PROBLEM *Solver*[™] BULLETIN

Clunking and excessive noise from front end

Ford Escape/Mazda Tribute/Mercury Mariner

MOOG® K80104 Sway Bar Link

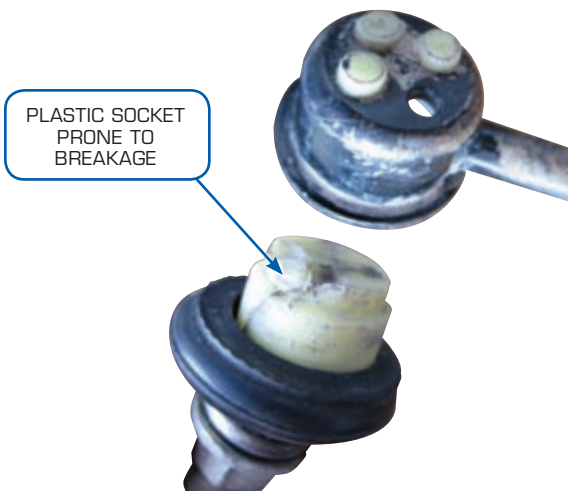
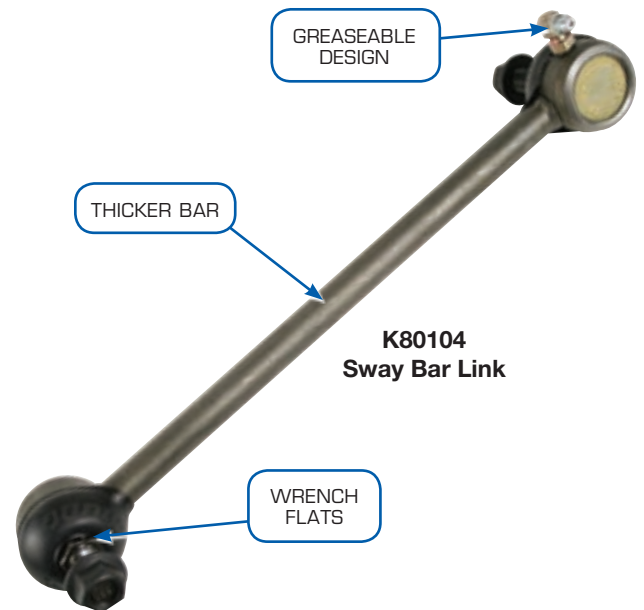
Owners of Ford Escapes, Mazda Tributes and Mercury Mariners may complain of rattling and/or clunking noises coming from the front end of their vehicle. This is more than likely caused by failed OE sway bar links.

- The non-greaseable design is prone to premature wear due to intrusion. This causes the metal ball stud to corrode quickly, abrading the bearing surface. This cycle of corrosion and wear causes the socket to quickly loosen, allowing excessive play and noise from the front end.
- The OE design uses plastic bearings, which are susceptible to breakage.

- MOOG's durable powdered-metal "gusher" bearing design keeps lubrication at the bearing surface, reducing friction, for longer life.
- Greaseable design flushes contamination.
- Wrench flats at the base of the stud allow for a positive hold and the use of sockets, for quick and easy installation and removal.
- Thicker bar adds strength and durability.
